May 7, 2025

Mr. David Nguyen
Los Angeles County Public Works
900 S. Fremont Avenue
Alhambra, CA 91803
dnguyen@pw.lacounty.gov

Re: Chiquita Canyon Landfill – CUP Condition No. 69 Report

Figure 8. Fissure and Crack Monitoring Report for February 2025. (Source: Geo-Logic Associates)

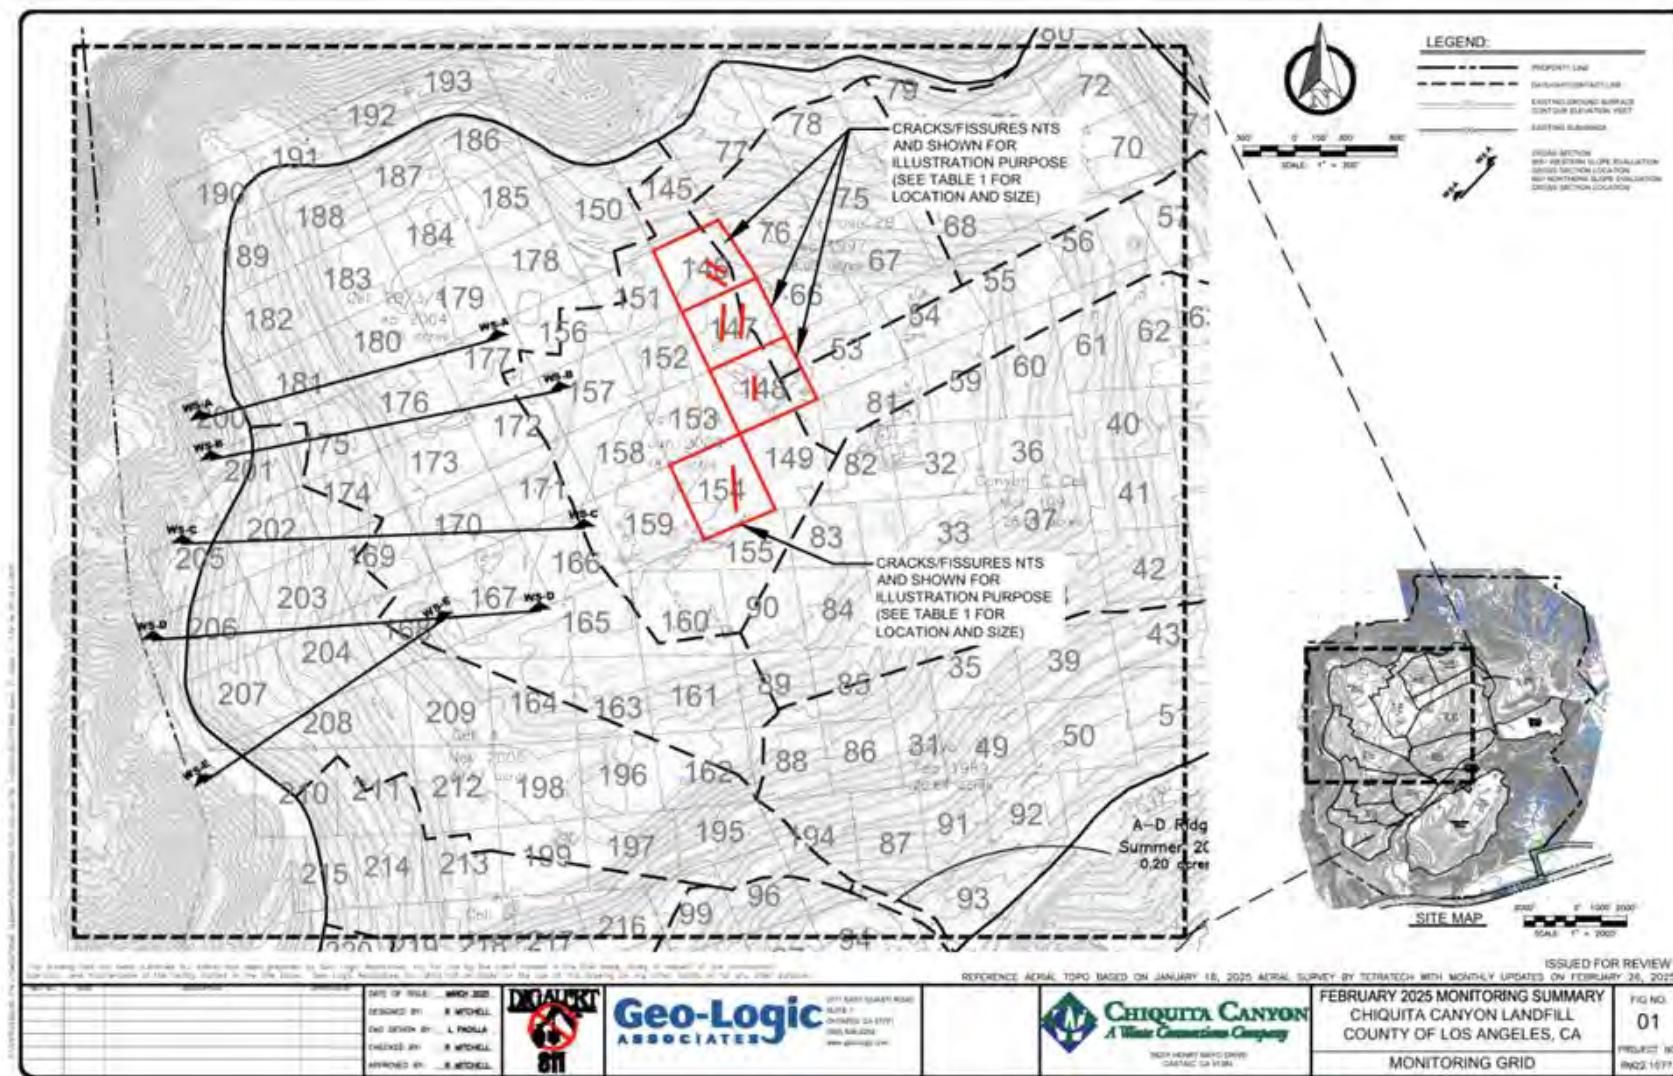
The CCL Settlement and Fissure Reports also align with the TMP temperature spikes data in grids. CCL's consultant, Geo-Logic Associates, provided a summary map of the recently occurring fissures in February 2025 (see **Figure 8**). Significant fissures and areas where the soil collapsed were documented in Grids 146, 147, 148, and 154. CalRecycle also reviewed FLIR data from October 2024; however, CCL has refused to provide the temperature layer on each photo. All data should be available.

Figure 1. Temperature profiles over six weeks from 1/9/2025 to 2/19/2025 from SCS report dated February 20, 2025.

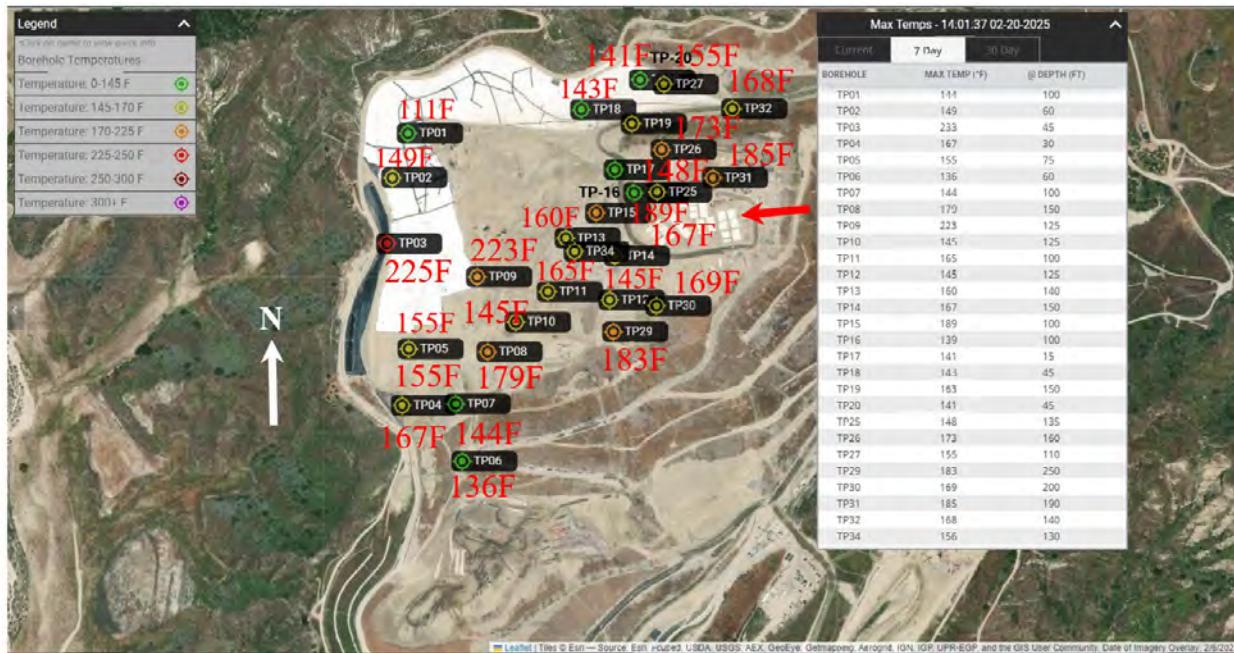
SCS presents Waste Borehole Maximum Temperature Profiles Over 6 Weeks from January 9, 2025 to February 19, 2025.⁶ An aerial image of CCL with a table of maximum temperatures is included in the subject SCS Report and reproduced in **Figure 1**. I have placed the maximum waste temperature from the table in **Figure 1** adjacent to some of the gas extraction wells to facilitate understanding the extent of the SET Event, especially on the east side of CCL. **Figure 1** shows waste temperatures of 183°F and 185°F at the eastern side of the top deck of the CCL. This means the SET Event has migrated from the western slope (TP03) to the eastern side of the CCL (TP31). Expansion of the SET Event has the following implications:

- Elevated temperatures (185°F to 189°F) surround the leachate tank farm (see red arrow in **Figure 1**). This area is going to undergo significant settlement, if it has not already started to do so, due to thermal breakdown of the buried waste. This settlement will cause differential movement of the leachate tanks, which could result in a leachate release. As a result, I recommend the leachate tank farm be moved off the top deck and to a site off the CCL and on native soil because the SET Event continues to expand.

end to just south of TP06 shown in **Figure 1**. In other words, the exposed geomembrane cover would cover about 183 acres and leave only about 13 acres at the southern end of the CCL uncovered for current disposal operations.

Figure 2. Extent of elevated temperatures from March 27, 2024 to February 26, 2025.

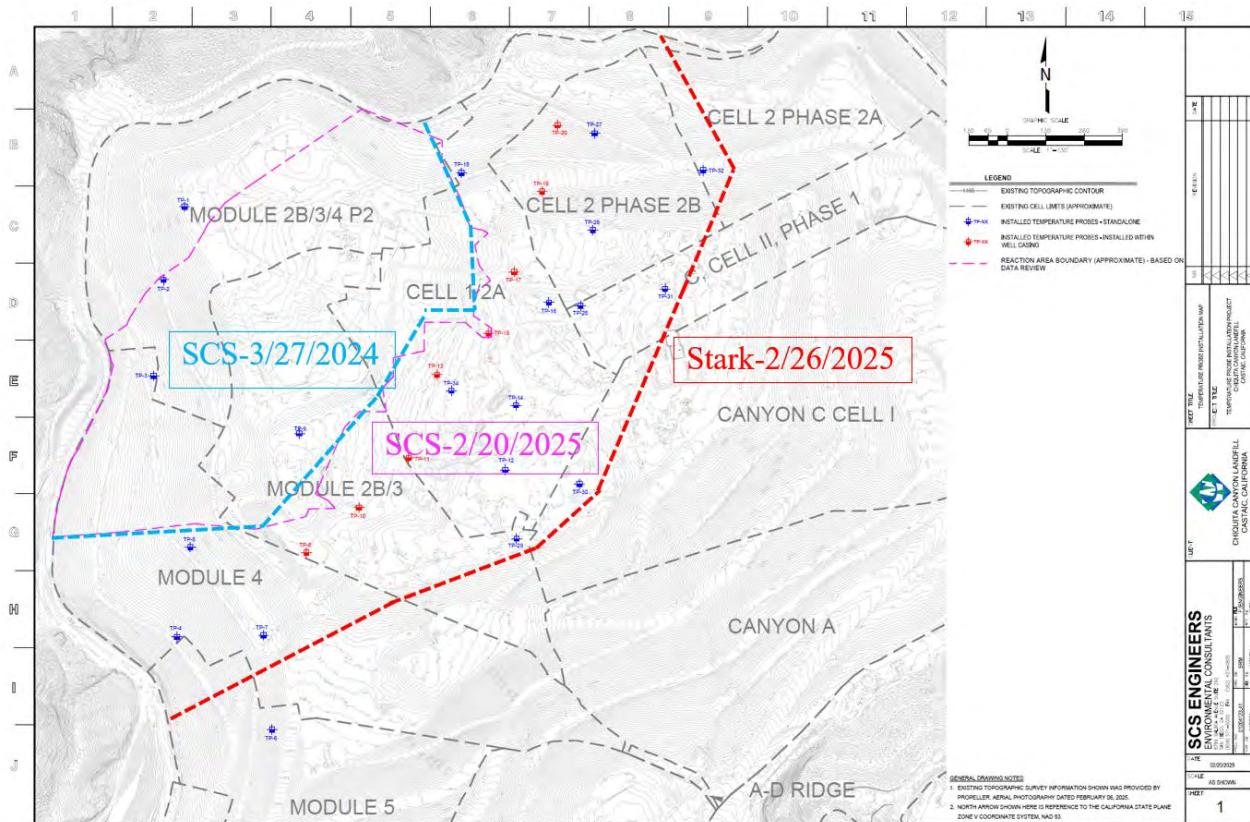
Figure 2 presents Sheet #1 from the SCS Report that presents the Waste Borehole Maximum Temperature Profiles Over 6 Weeks from January 9, 2025 to February 19, 2025.⁷ The dashed pink line represents the extent of the SET Event as determined by SCS on February 20, 2025. This extent is slightly larger than the dashed blue line, which represents the extent of the SET Event on March 27, 2024 as reported by SCS in the initial Soil Reaction Break/Barrier Plan.⁸ **Figure 2** also presents my extent of the SET Event as of February 26, 2025 (see dashed red line) based on the Waste Borehole Maximum Temperature Profiles Over 6 Weeks from January 9, 2025 to February 19, 2025.⁹ **Figure 2** shows the western slope and entire top deck of the CCL is now part of the

SET Event, which is a significant increase over the extent reported by SCS on March 27, 2024¹⁰ and February 20, 2025.¹¹ Based on **Figure 2**, SCS believes the SET Event only covers about 28 acres as of February 20, 2025 whereas my extent of the SET Event covers about 90 acres.
